Work Order ID 89391

Item Name: Crosstube Low Standard Fwd

DART AEROSPACE LTD		Work Order:	89391
Description: Crosstube Low Fwd (205/212/412)		Part Number:	D212-664-107
Inspection Dwg: D212-664-147 Rev: B		Page 1 of 1

DRAWING NO. D212-664-147	TITLE CROSSTUBE ASS'Y (205 LOW FWD)	REV. B	DART AEROSPACE LTD ENGINEERING ORDER		D.E.O. NO. D212-664-147-B-1	SHEET NO. SHEET 1 OF 1	SCALE NTS
DRAWN <i>92</i>	CHECKED <i>ASS</i>	MFG. APPR. <i>123</i>	APPROVED <i>WJ</i>		DE APPR. <i>WJ</i>		
DATE 11.07.15	DATE 11.07.20	DATE 11.07.21	DATE 11/07/21		DATE 11.07.21

**D212-664-147/-147B
ASSEMBLY DETAIL** △ B

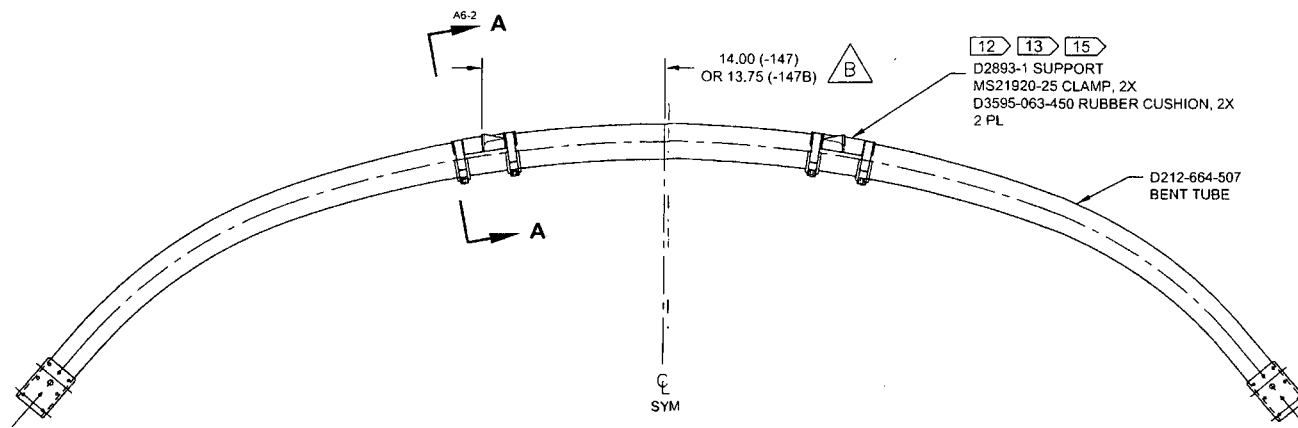
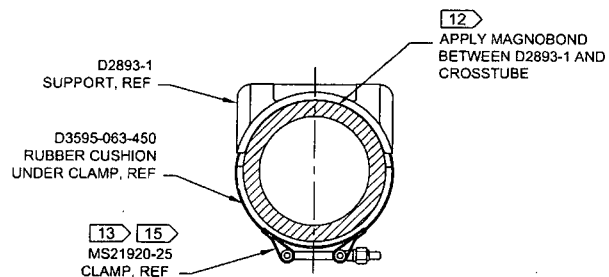
PURPOSE:

REPLACE MAGNOBOND WITH PROSEAL.

NOTE 12 & 15, SHEET 1 IS AMENDED AS FOLLOWS:

IS:

- 12) TO INSTALL D2893-1 SUPPORT: ABRASE MATING SURFACE OF SUPPORT AND CROSSTUBE WITH 180-GRIT SANDPAPER AND REMOVE RESIDUE WITH MEK (OR EQUIVALENT). APPLY A 0.04" TO 0.07" THICK LAYER OF PROSEAL 890 CLASS B-2 (OR AMS-S-8802 CLASS B-2) SEALANT TO MATING SURFACE OF SUPPORT.
- 15) TORQUE CLAMPS 80 TO 100 IN-LB. ENSURE AT LEAST 1.5 THREADS SHOWING IN SAFETY AND THAT NUT HAS NOT BOTTOMED-OUT AFTER TORQUING. **PRIOR TO PACKAGING, RE-CHECK TORQUE ON CLAMPS AFTER PROSEAL 890 SEALANT HAS CURED FOR 72 HOURS.**

WAS:

- 12) INSTALL D2893-1 SUPPORT USING 0.03" TO 0.06" THICK LAYER OF MAGNOBOND 6398 TO THE SURFACE OF D2893-1 THAT WILL BE IN CONTACT WITH THE CROSSTUBE PER QSI 015. LET CURE FOR 12 HOURS AFTER INSTALLATION AND PRIOR TO PACKAGING.
- 15) TORQUE CLAMPS 80 TO 100 IN-LB. ENSURE AT LEAST 1.5 THREADS SHOWING IN SAFETY AND THAT NUT HAS NOT BOTTOMED-OUT AFTER TORQUING.
